MCPB
Item # 8
5/9/02

MEMORANDUM

REVIEW TYPE: Final Water Quality Plan and Site Plan Review
APPLYING FOR: Approval of 487 dwelling units (153 SFD, 202 TH's and 132 multifamily units) inclusive of 46 MPDU's on 77.61 acres
PROJECT NAME: Clarksburg Town Center Phase II
CASE #: 8-02014
REVIEW BASIS: Sec. 59-D-3, M. C. Zoning Ordinance

Park/School Site

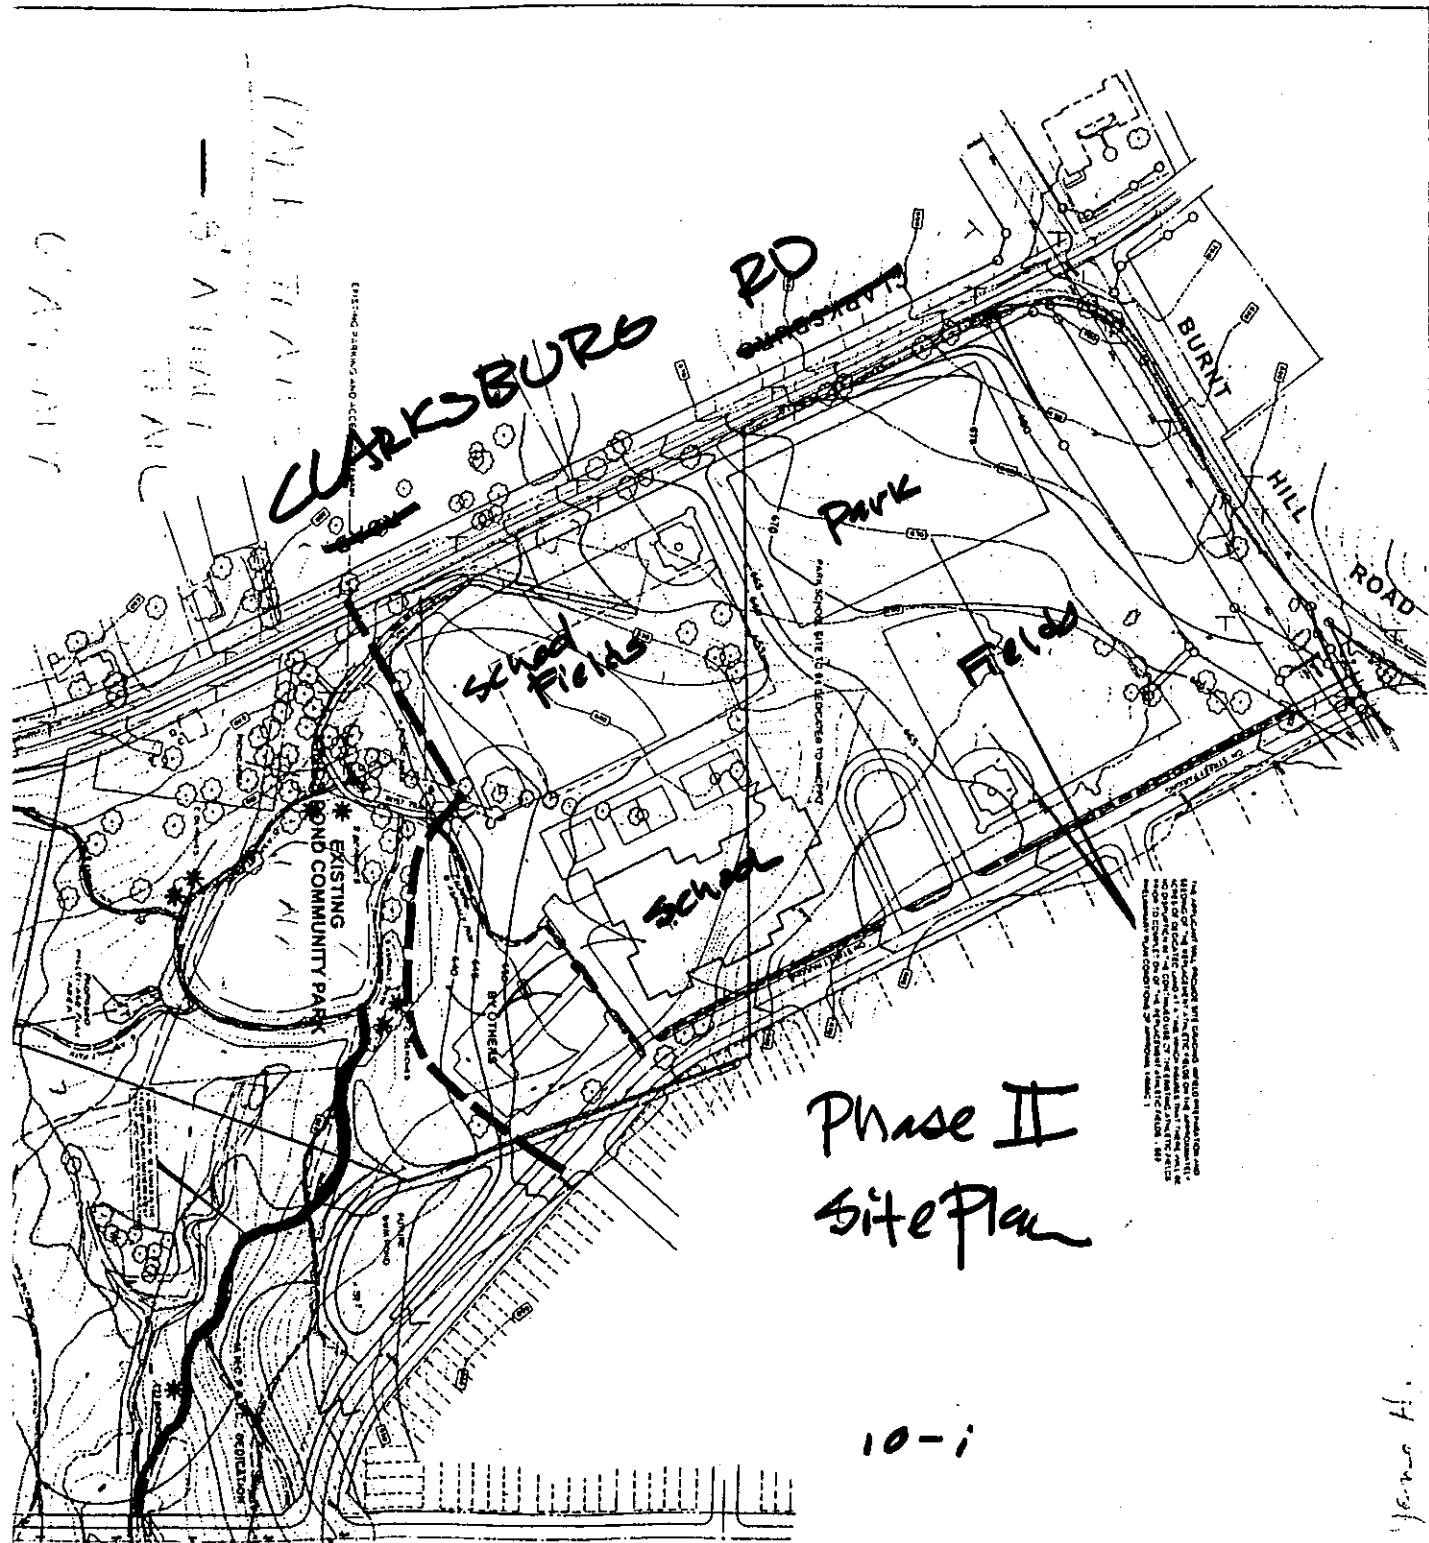
In the course of site plan review, as the park/school plan was being developed, issues of concern have developed. A letter from MCPS is attached which recites their concerns with the current school site location due to the severe grading problems associated with the site. They are asking the Planning Board to require the applicant to provide engineered fill to compensate for the considerable elevation changes – 20 feet in some areas of the site.

Current plans call for the construction of two ballfields that will be dedicated to the M-NCPPC. Plans call for a ten-foot grade difference between these fields and the school property, necessitating the construction of a retaining wall. Montgomery County Public Schools requests that as a condition of the site plan approval, the applicant be required to re-configure the ballfields, locating them further from the school property line, or if this is not feasible, construct an adequate retaining wall to accommodate the difference in grade.

MCPS requests that as a condition of site plan approval, the applicant provide adequate engineered fill for the building and rough grade the remainder of the school site to allow school construction at reasonable cost. Alternatively, if this cannot be done, MCPS will consider another site within the subdivision.

With the Planning Board's concurrence, the final grading plan will be finalized after the Site Plan approval in order to work out grading and other details of the submittal listed in the conditions above.

MPDU LOCATION PLAN

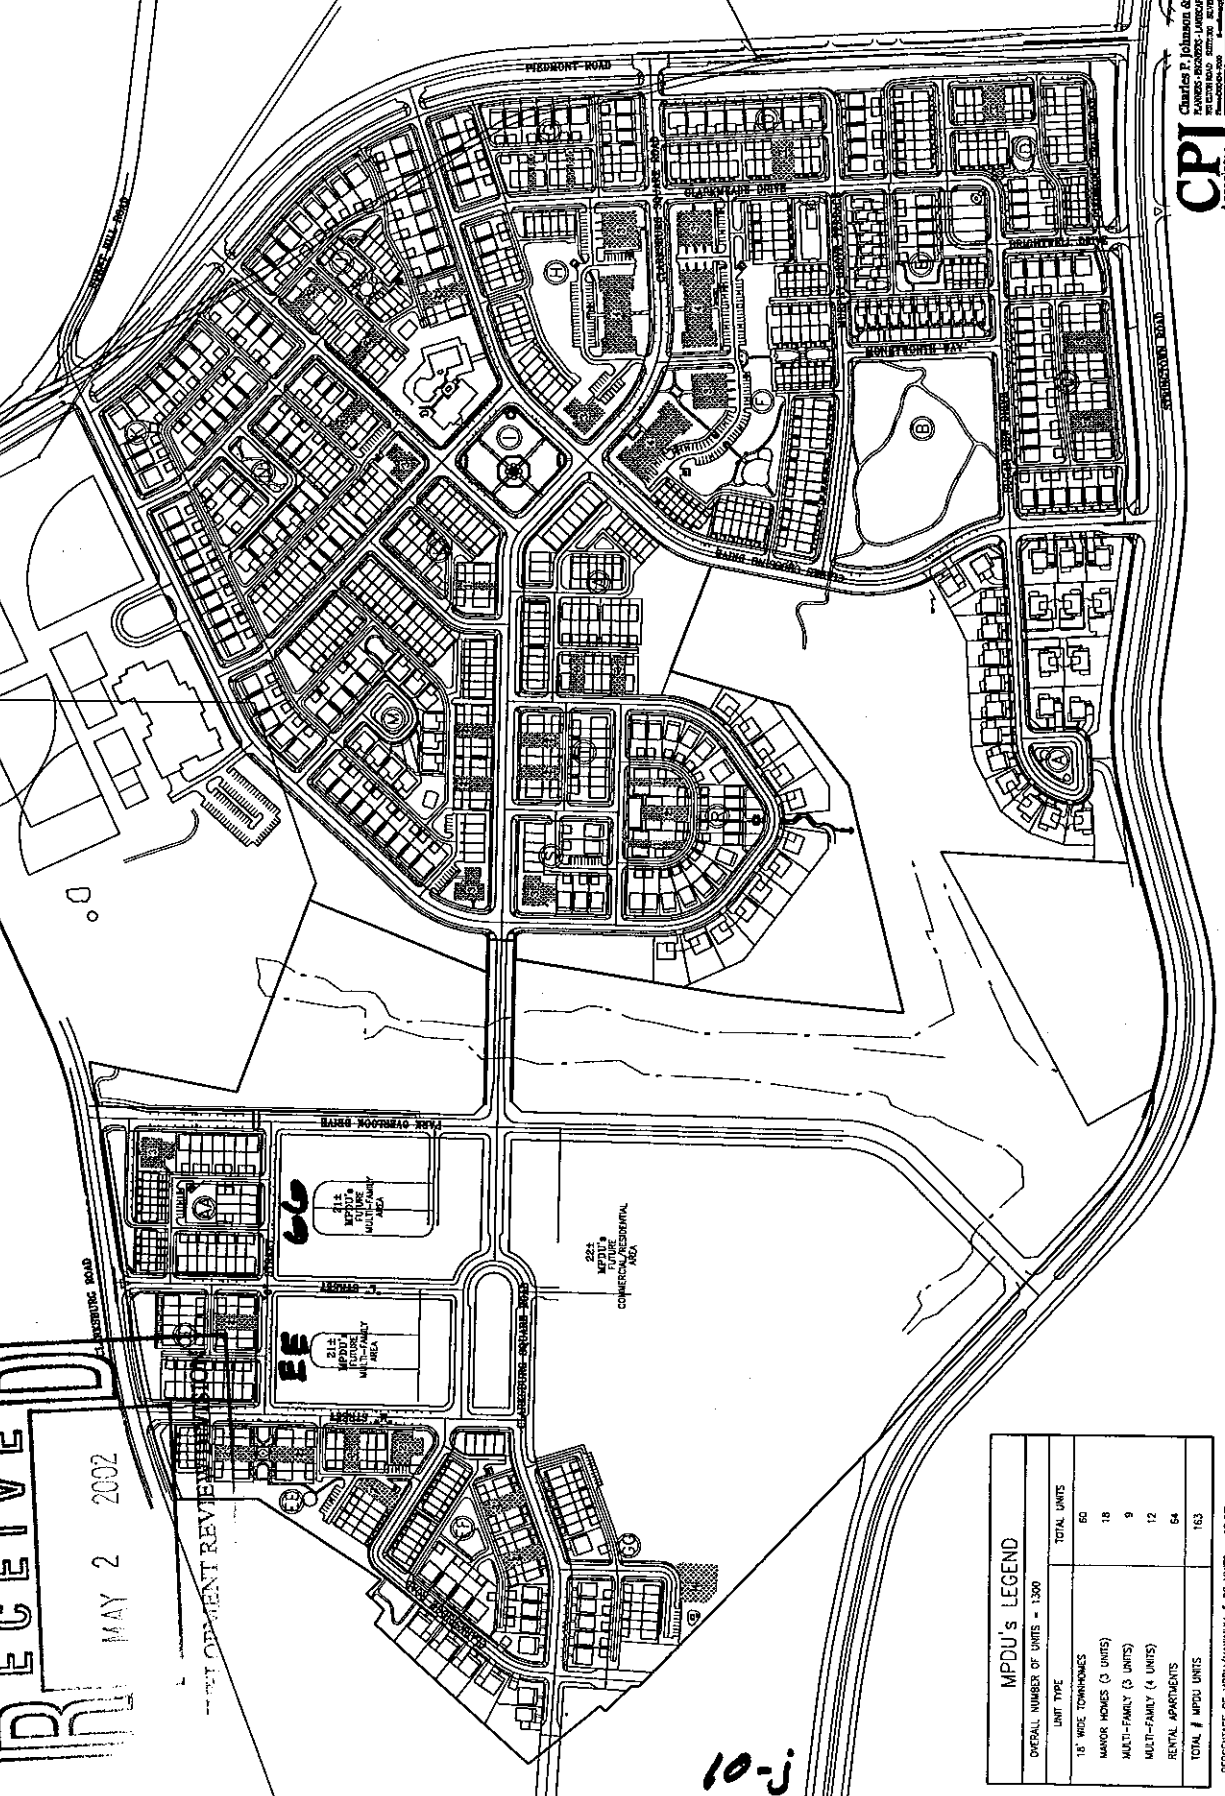
In order to maintain an equitable balance of MPDU's, all units within Blocks EE and GG of Phase I Site Plan 8-98014 as shown in MPDU exhibit dated May 2, 2002 (attached) will not be constructed until the Planning Board approves a revision of those blocks (proposed to be resubmitted for approval).

Page 2 -- Wynn Witthans - Clarksburg Town Center Phase II - May 2, 2002

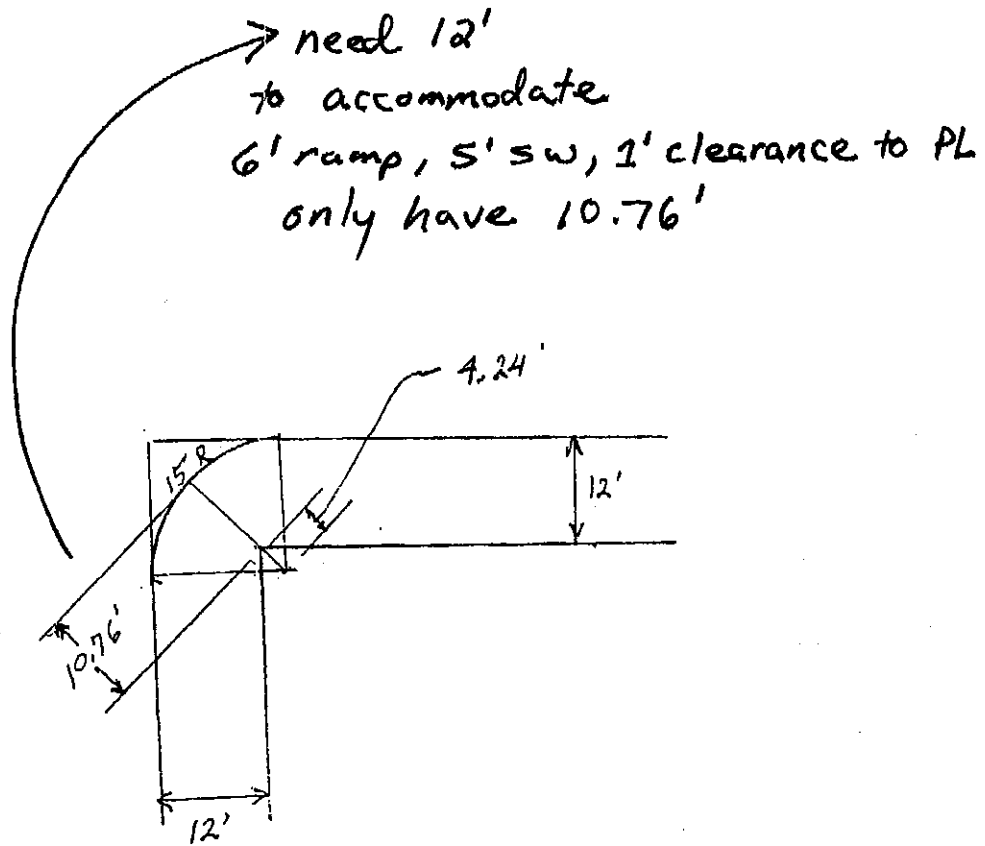
- Block N -- the street block adjacent to Lots 39-42 must be private since its only egress is via an alley on the north. We recommend that a waiver be granted to allow single - family houses on a private street. The loop road around the central square should be shown as one-way counterclockwise. A horizontal curvature waiver is needed for the curve on the southwest corner of the square.

- Block M -- the loop road around the square will need a horizontal curvature waiver. However, the radius on the curve on the east corner still needs to be increased. The loop road around the square should be shown to operate one-way counterclockwise.

- Grapevine Ridge Road will operate one-way northbound; this should be shown on the plan. The chokers at either end of Grapevine Ridge Road south of Clarksburg Square Road should be eliminated.

- Curb ramps at intersections must meet MCDPWT and ADA dimensions; this may require some additional right-of-way (truncation) at some intersections. The attached drawing shows that where truncations are not provided on tertiary streets, the required space to install the six foot long ramp, a five foot level sidewalk area and one foot of clearance to the property line is not available.
